Grandview Reserve Project

Testimony on:

Potential Downstream & Floodplain Impacts to Adjacent Property Due to Master Development Drainage Plan for East Fork and East Fork Tributary of the Gieck Ranch Drainage Basin

Scott D. Reid & Susan K. Charles

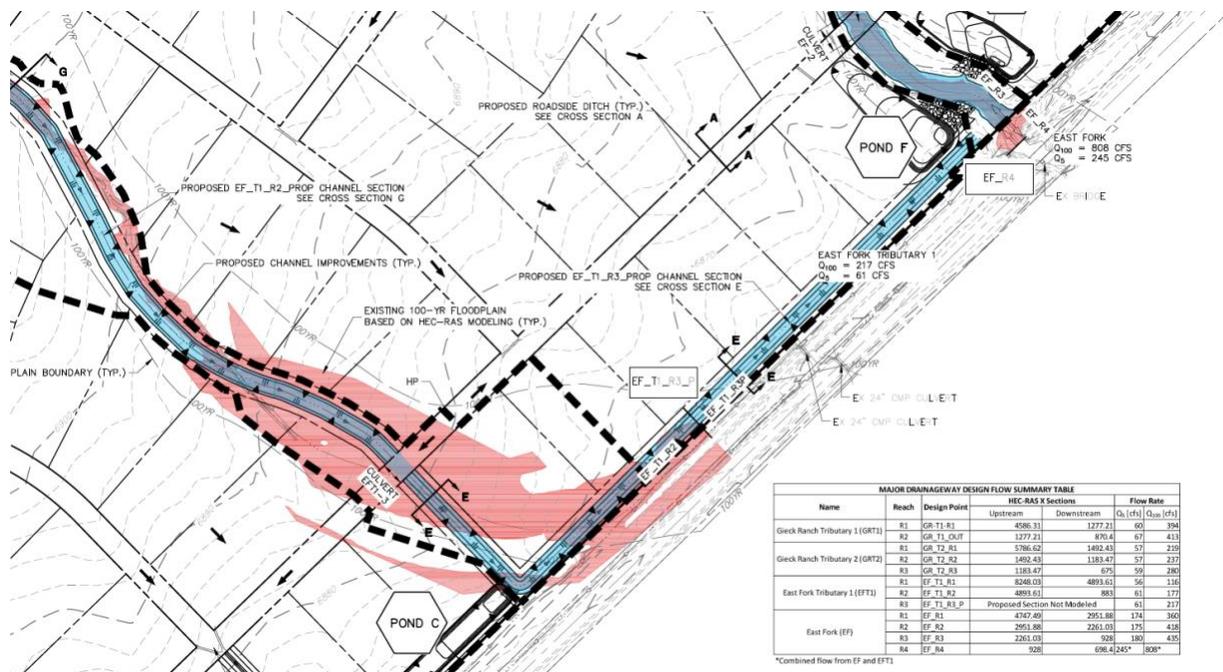
We were told by Mike Bramlett of JR Engineering in 2019, during development of the original Grandview Reserve drainage plans, that with the *proposed* upstream grading in the EFT drainage and the *proposed* channelization along the southern border of Grandview Reserve along the Rock Island Trail, there would be a *diversion* of runoff water into the EF that would increase the flow as it entered our property via the EF under the Hwy 24 bridge. The diverted flow associated with those proposed changes is consistent with the outflow values in the table (shown in Figure 2) for EFT from the 4 Way Ranch LOMR, March 2004. This would have made the outflow from the EF into our property either Q5 = 241 cfs and Q100 = 841cfs or Q5 = 245 cfs and Q100 = 808 cfs (shown on Map Sheet 1 of 7 or Map Sheet 6 of 7 (respectively) from the Grandview Reserve Preliminary Grading Plan dated 1/25/2019). See Figure 3 (includes link to map sheets). We felt that this was unsatisfactory as it would contribute significantly to the potential for destabilization of the EF channel through our property as noted earlier.

The tradeoff for redirecting flow from the drainage along the area adjacent to EFT on the Grandview site was for the purpose of shrinking the size of the 100-year floodplain zone in that part of the development. This design, including the aforementioned grading, channelization, and the removal of the culverts under Hwy 24 created changes that were reflected in the proposed LOMR for the floodplain along the EFT on both

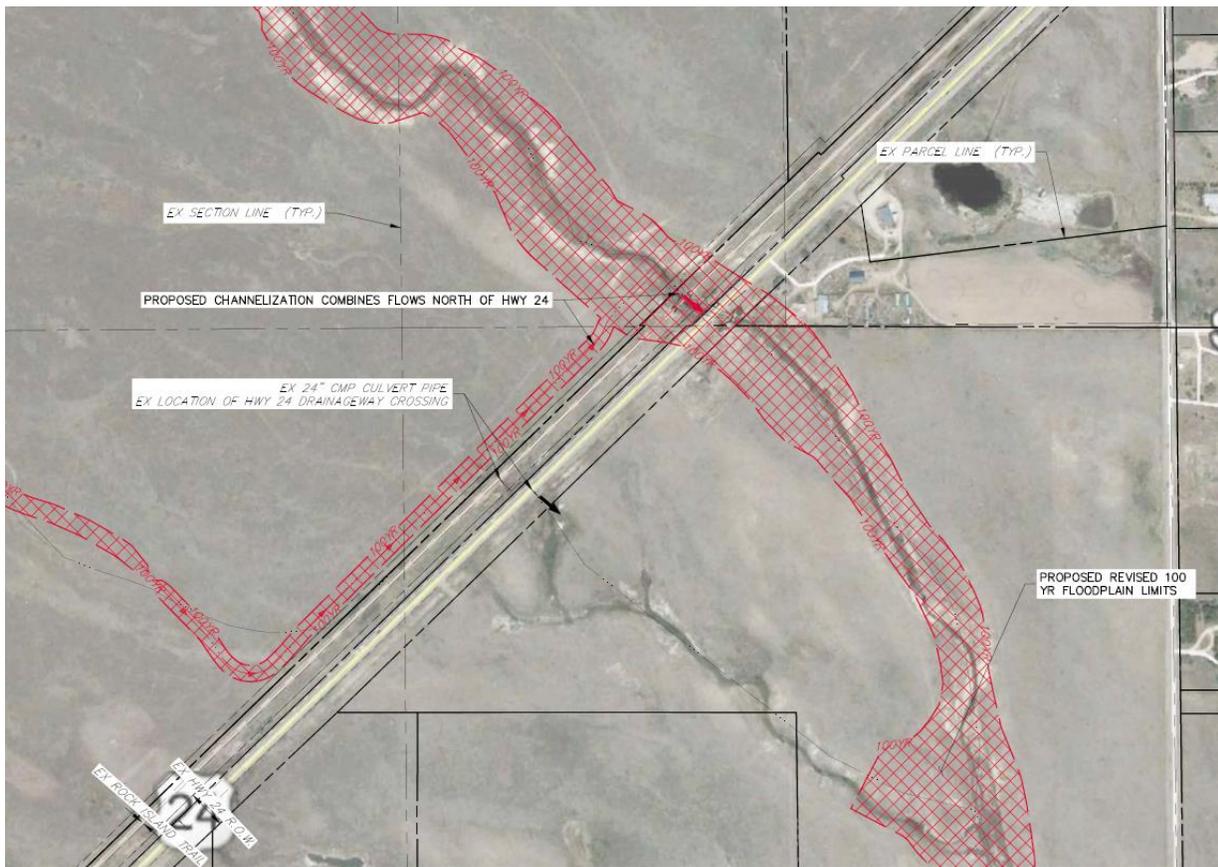
properties (shown in Figure 4). Currently, there is indeed evidence of water conveyance through the Hwy 24 culverts between the EFT channel on the Grandview property (that is “indistinct” near Hwy 24) and the EF on our property. South of Hwy 24, there is a reappearance of the EFT channel and a change in vegetation type is evident in an area of seasonally standing surface water that drains to the EFT channel on our property. The following description from the earlier JR Engineering Preliminary Drainage Plan discusses this:

It is evident that new revisions to the floodplains will be required for the currently proposed development. We assume this will involve a similar strategy to what JR Engineering proposed for the EFT floodplain. The current MDDP seems to assume the 2019 proposed changes to the EFT are already *the current condition*. Is this an oversight, an incorrect assumption, or are you proposing a diversion connection/channel that isn’t shown on the current MDDP?
